August 2025
Design Development Updates

Upper Brook Street Masterplan (McLaren / Kadans)

UBS-SRA-XX-XX-RP-A-00101

This document has been produced by Sheppard Robson and proposes minor changes to the approved Sci-Tech scheme located in Upper Brook Street, Manchester.

Cottenham Street Elevation

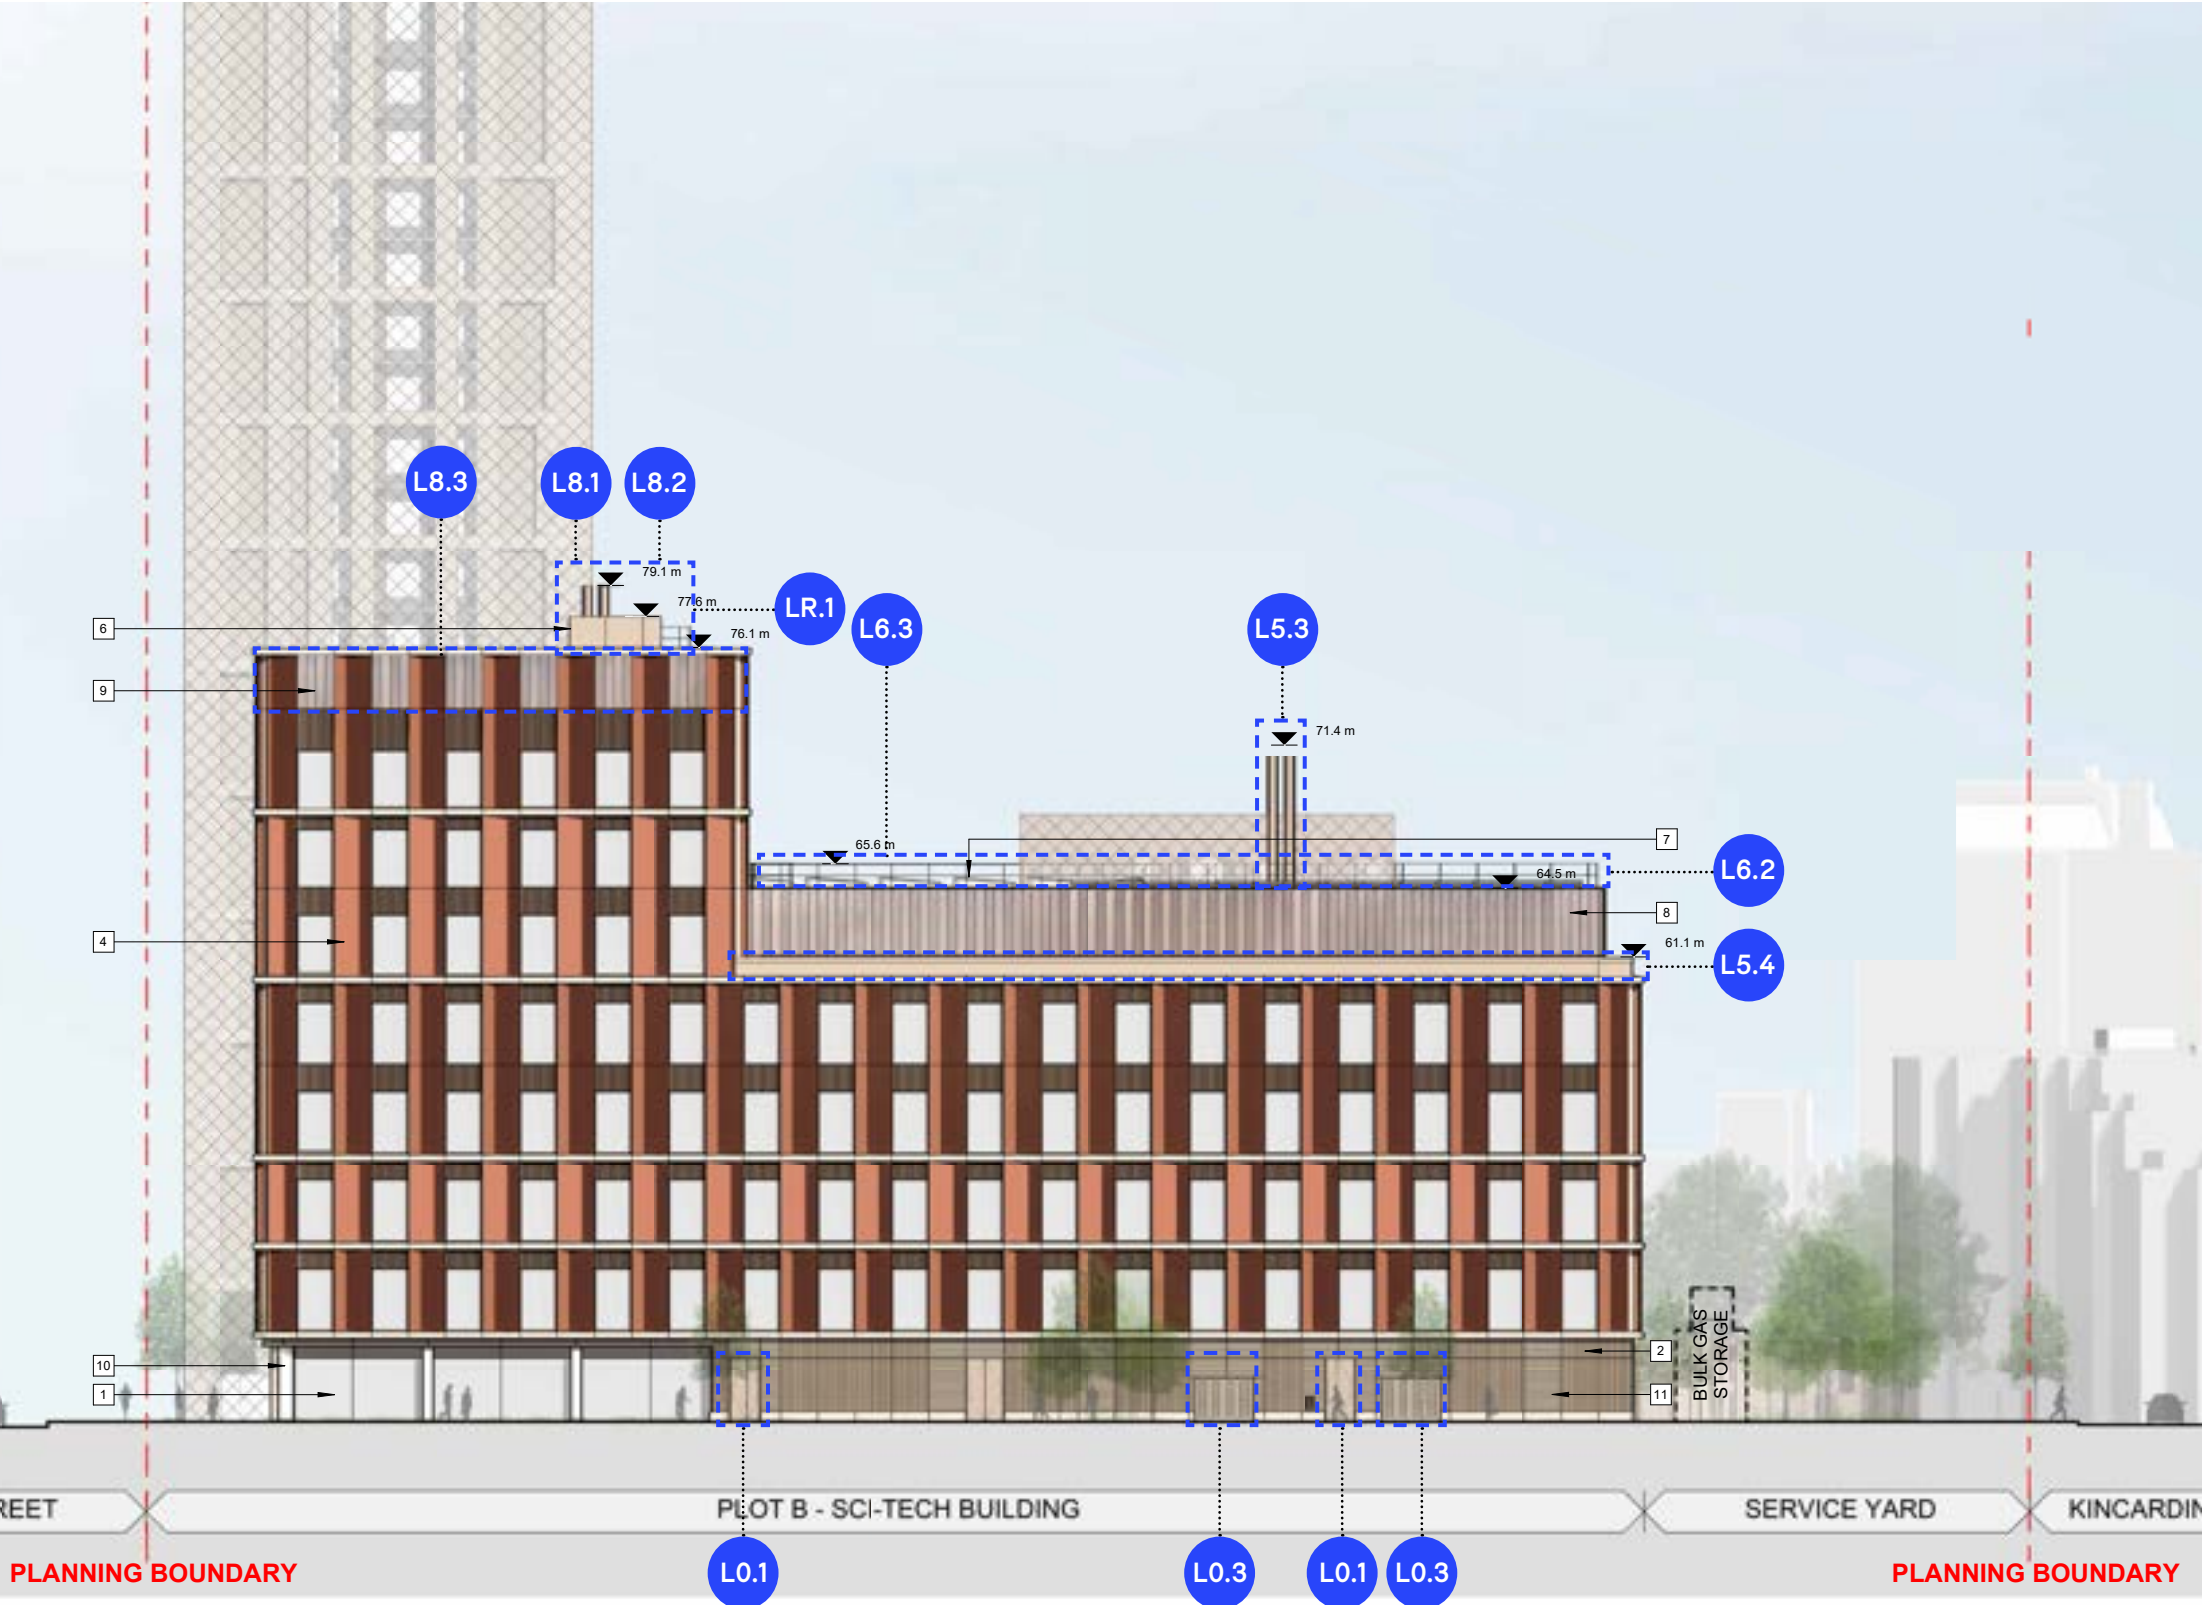
- L0.1** Escape door sizes have been reviewed following coordination with the fire consultant.
- L0.3** The back of house facade was updated following IDNO coordination (introduction of their compliant doors).

- L5.3** The future tenant flue zone was clarified, and flues have been included for illustrative purposes.
- L5.4** The Level 05 parapet detail was developed.

- L6.2** A safety perimeter guardrail was added to the PV platforms.
- L6.3** The Atrium roof was lowered one level, from Level 07 to Level 06.
- L8.1** The core overrun footprint was slightly increased following cladding and structure coordination.

- L8.2** The future tenant flue zone was clarified, and flues have been included for illustrative purposes.
- L8.3** The plant screen location in the Level 08 roof was moved outwards to reduce the distance to the facade piers.

- LR.1** Core overrun safety perimeter guardrail added

Change Code	Drawings Affected	Description	Design Development Justification
L0.1	Refer to page 10	Fire Escape double doors sizes were updated	Door dimensions have been reviewed following coordination with the design team and specialists regarding width of escape route corridor and minimum widths of escape doors
L0.3	Refer to page 10	Back of house doors updated	Substation doors confirmed following coordination with IDNO
L5.3	Refer to page 22	Future tenant flue zone clarified	Following building services coordination, flue design and zone has been clarified, flues have been included for illustrative purposes.
L5.4	Refer to page 22	Level 05 parapet detail was developed.	Following facade development, the parapet detail was developed.
L6.2	Refer to page 28	PV Layout and platform rearranged. Safety perimeter guardrail added.	PV Layout arrangement and platform design updated following MEP design development. A safety guardrail has been added around the PV platform for health and safety reasons following access and maintenance specialist advice.

L6.3	Refer to page 28	The Atrium roof lowered by one level with changes to the Atrium roof design.	The atrium roof was lowered and developed through a series of workshops with specialists
L8.1	Refer to page 34	Core overrun extent increased	Core overrun extent reviewed following cladding design development
L8.2	Refer to page 34	Future tenant flue zone clarified	Following building services coordination, flue design and zone has been clarified, flues have been included for illustrative purposes.
L8.3	Refer to page 34	Plant screen location moved outwards	Allows for more MEP roof space
LR.1	Refer to page 40	Core overrun roof perimeter safety guardrail added	Core overrun safety perimeter guardrail added to access and maintain ventilation equipment on top of core overrun

Bay Study Consented

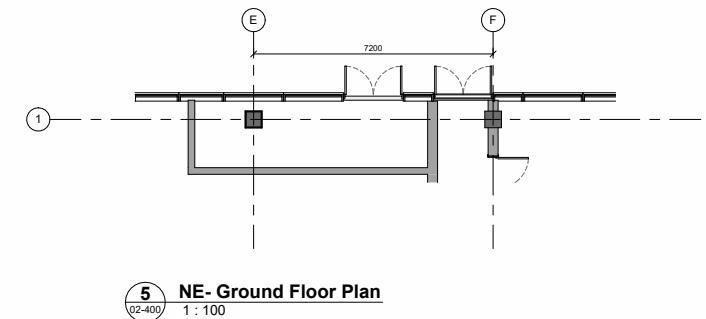
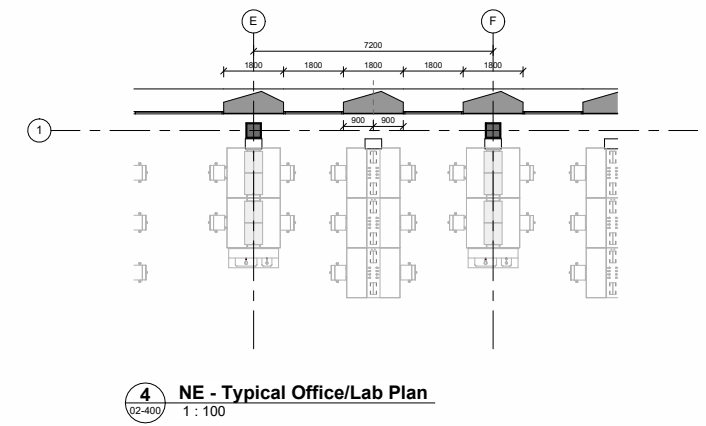
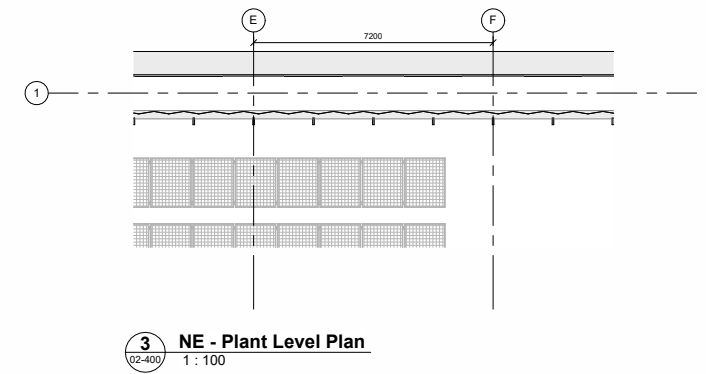
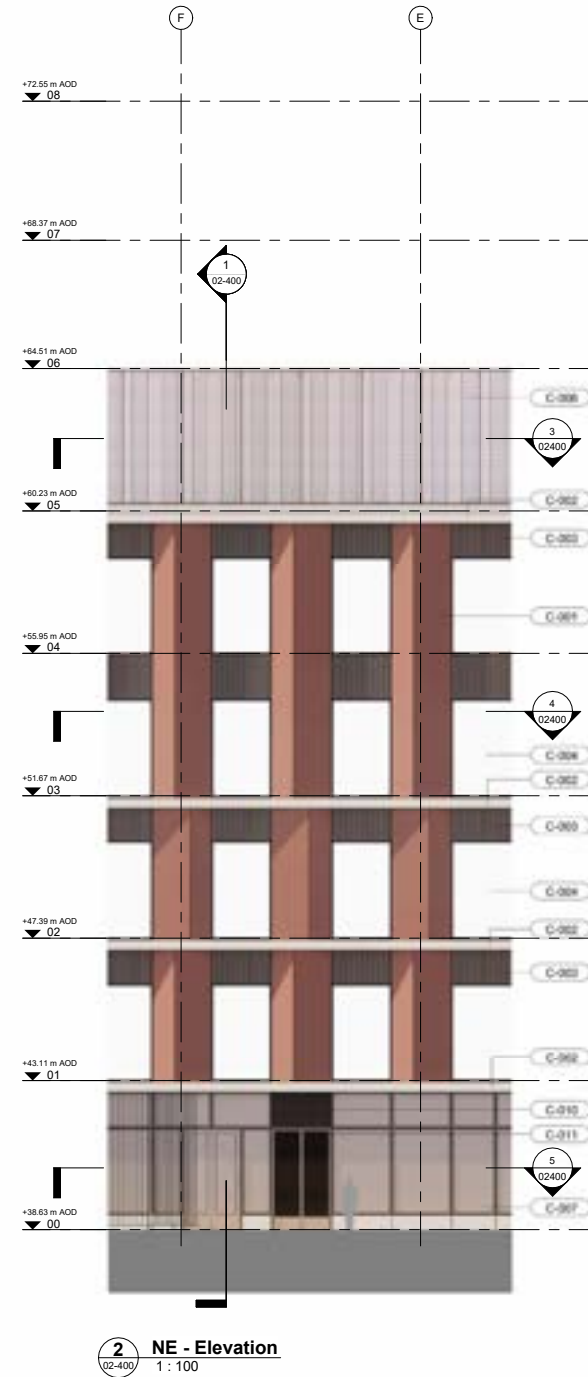
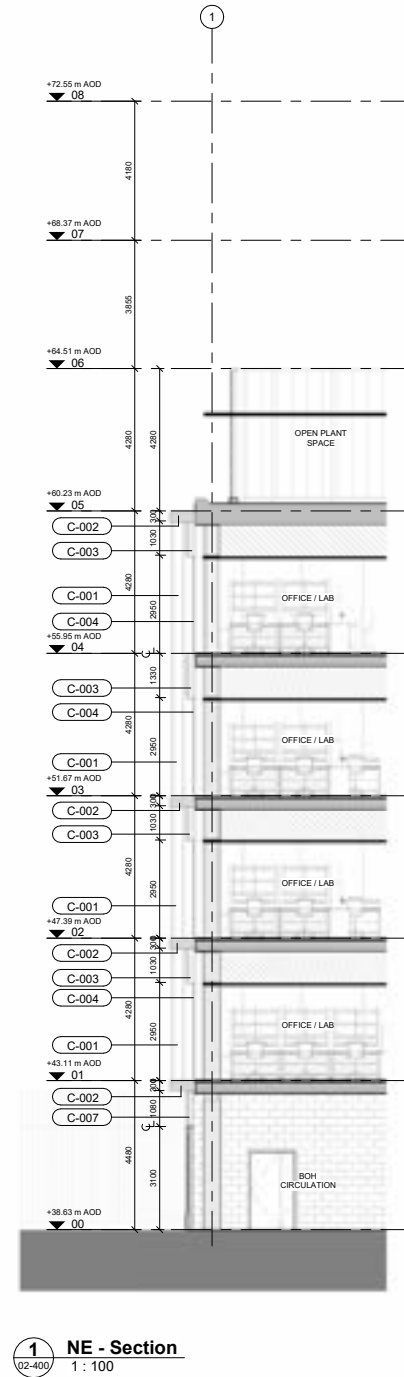
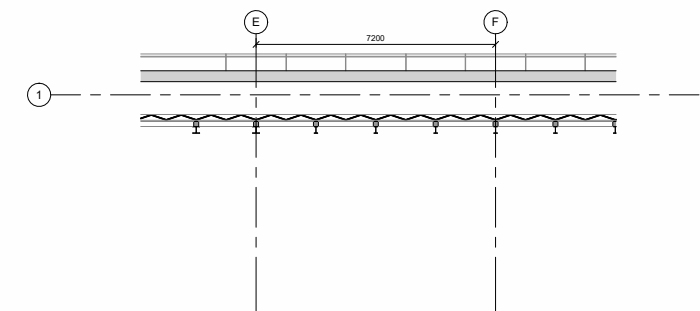
L5.4 The Level 05 parapet detail was developed.

Change Code	Drawings Affected	Description	Design Development Justification
L5.4	Refer to page 20	Level 05 parapet detail was developed.	Following facade development, the parapet detail was developed.

Bay Study Elevation

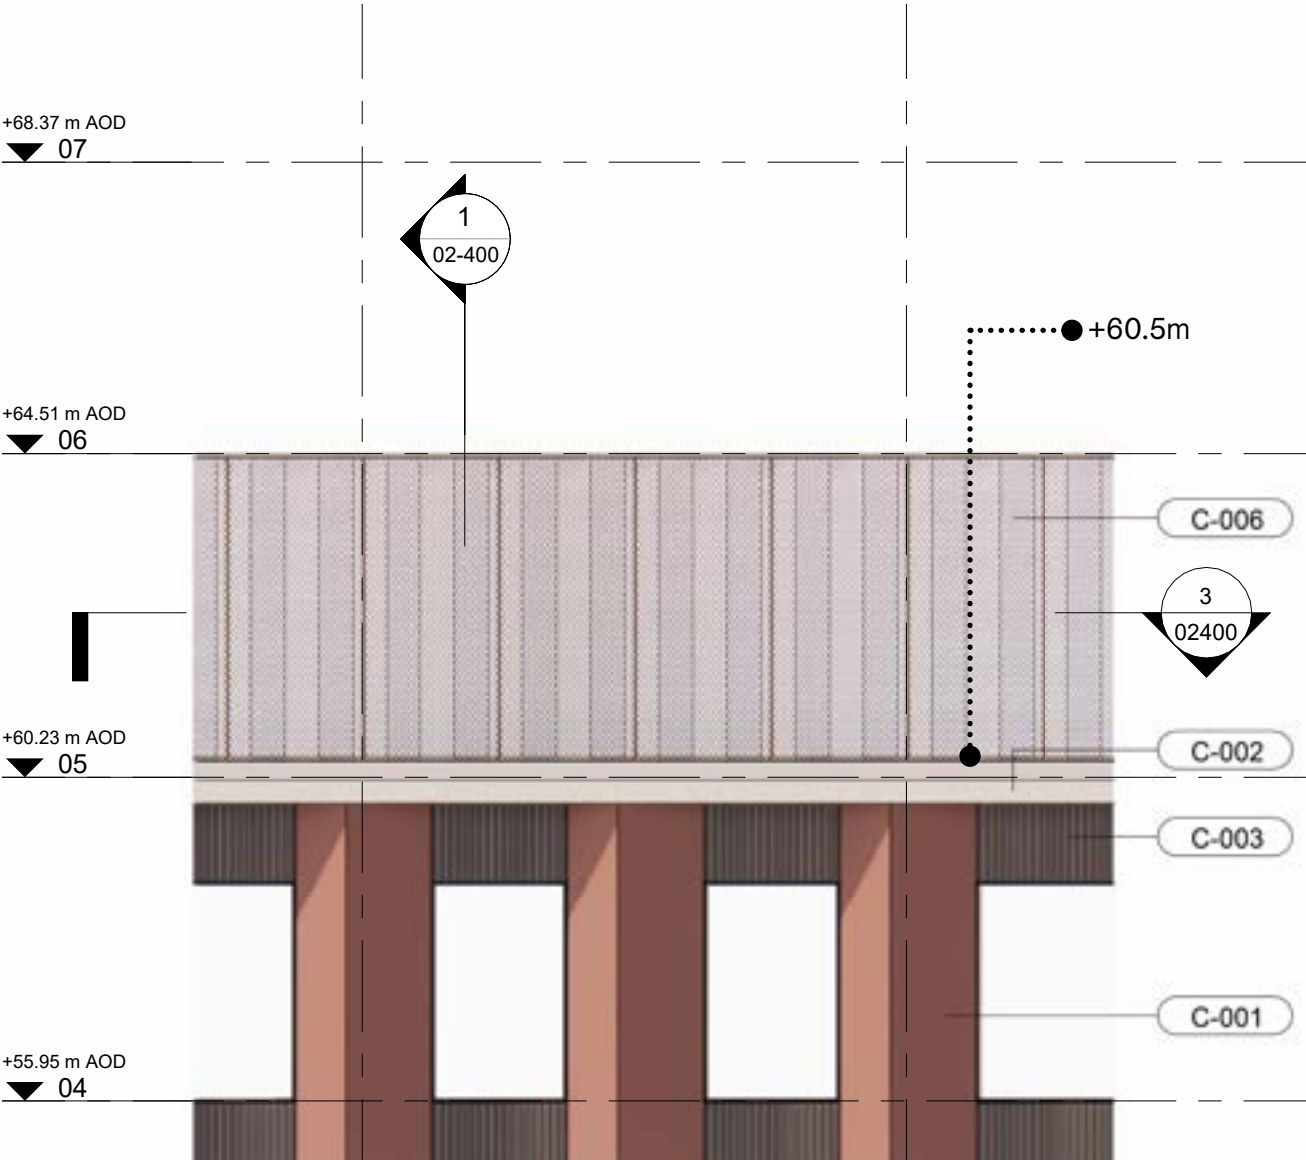
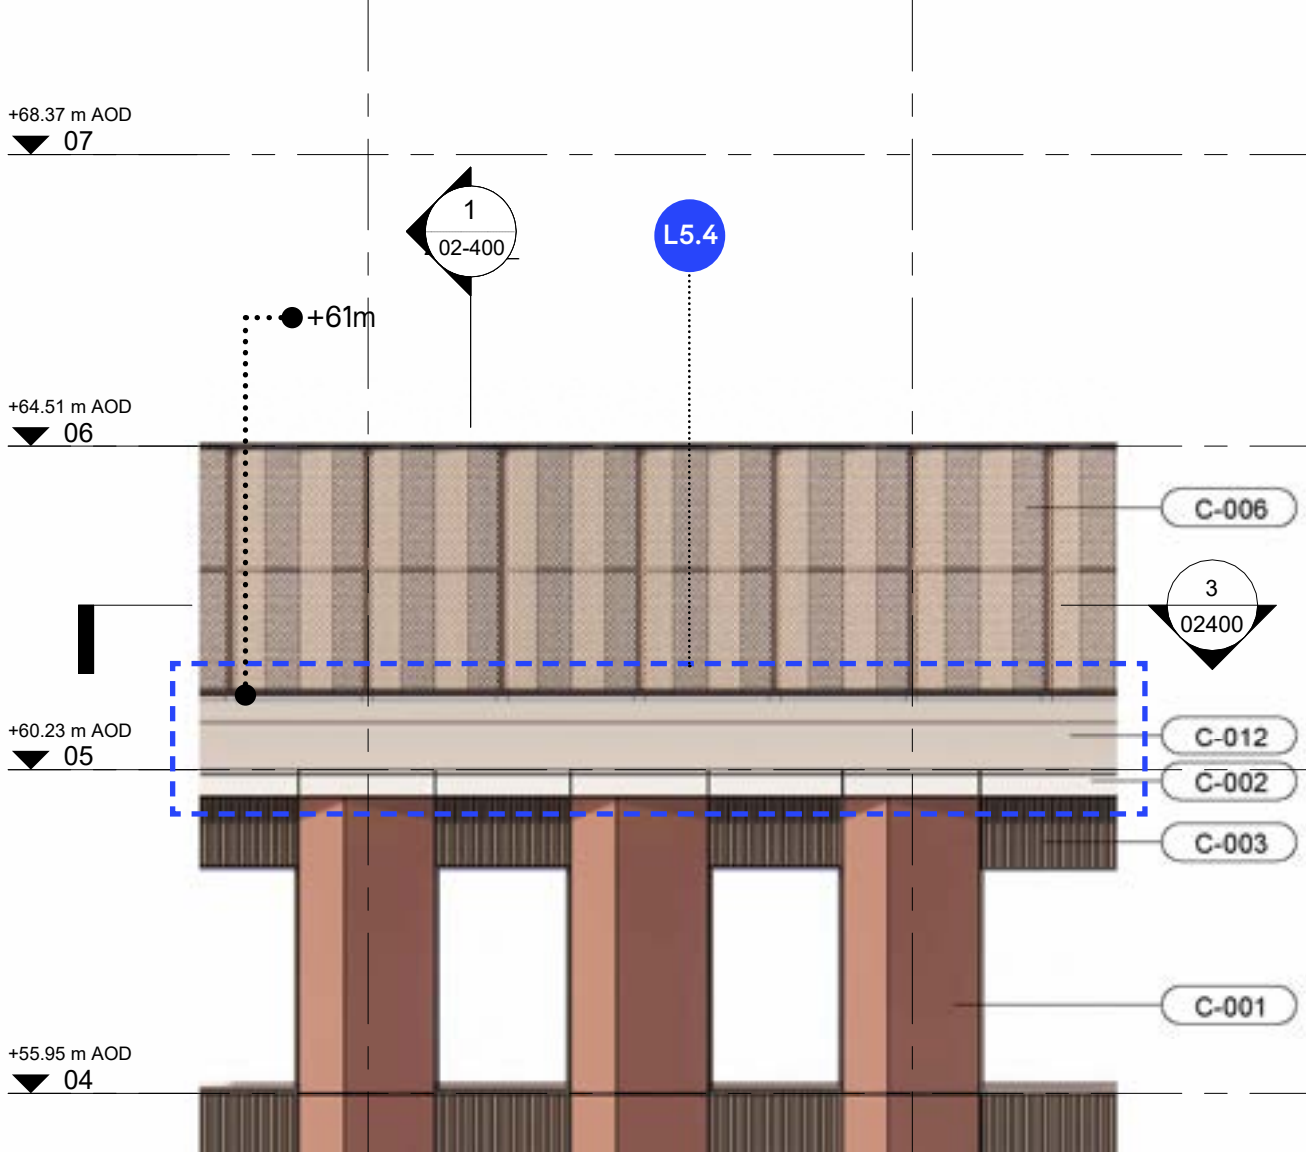
L5.4 The Level 05 parapet detail was developed.
